5 October 1980

EVALUATION OF DESIGN HAZARDS OF AIRBORNE ASH AND PYROCLASTIC FLOW FOR THE TROJAN POWER PLANT SITE.

Prepared for : Physicians for Social Responsibility (PSR)
SEARCH : 0312

FIGURE 5 Shaded areas are for depths greater than 3-feet, 5-feet, and 10- feet.
Depth at Trojan site is about 8-feet, compacted ash.

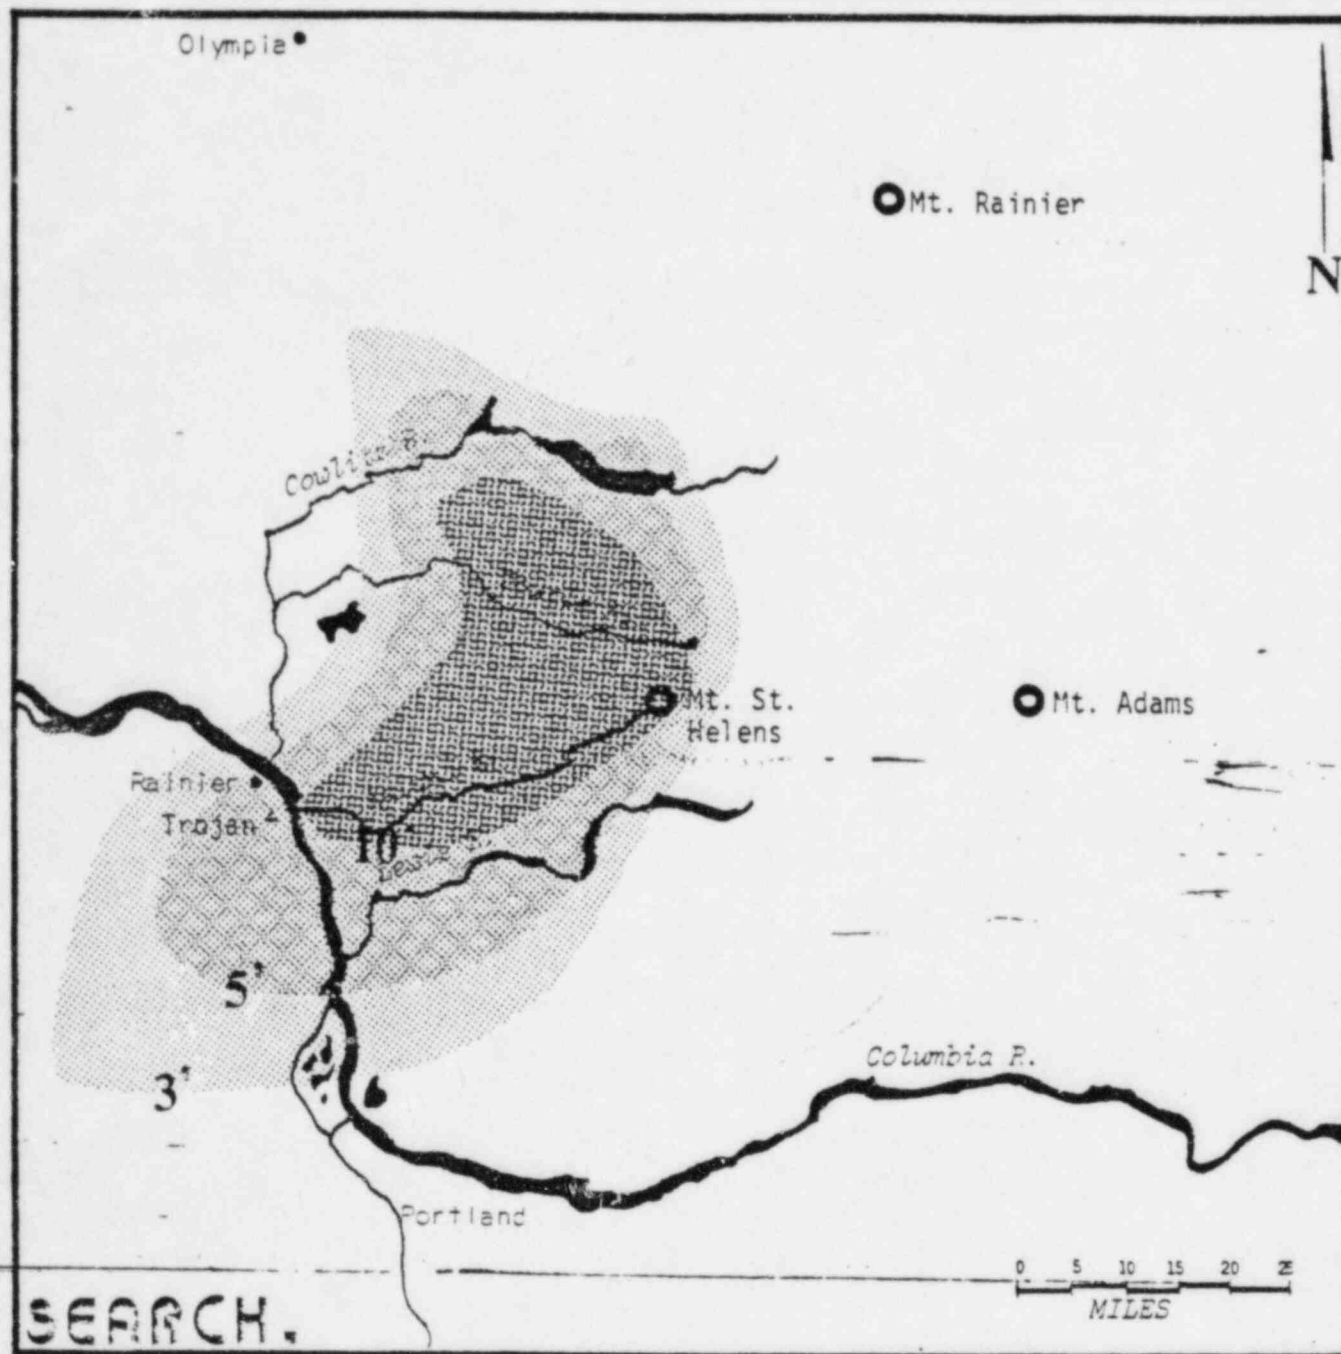
With this probability in mind, the Mt. Mazama eruption data can be superpositioned over Mount St. Helens, with the major lobe directed roughly toward the Trojan site, Fig. 5. This gives an idea of the potential ash fall at site from a severe eruption of Mount St. Helens. The result: About 8 feet of compacted ash at site. The initial fall of uncompacted ash would probably be at least twice this deep--16 feet.
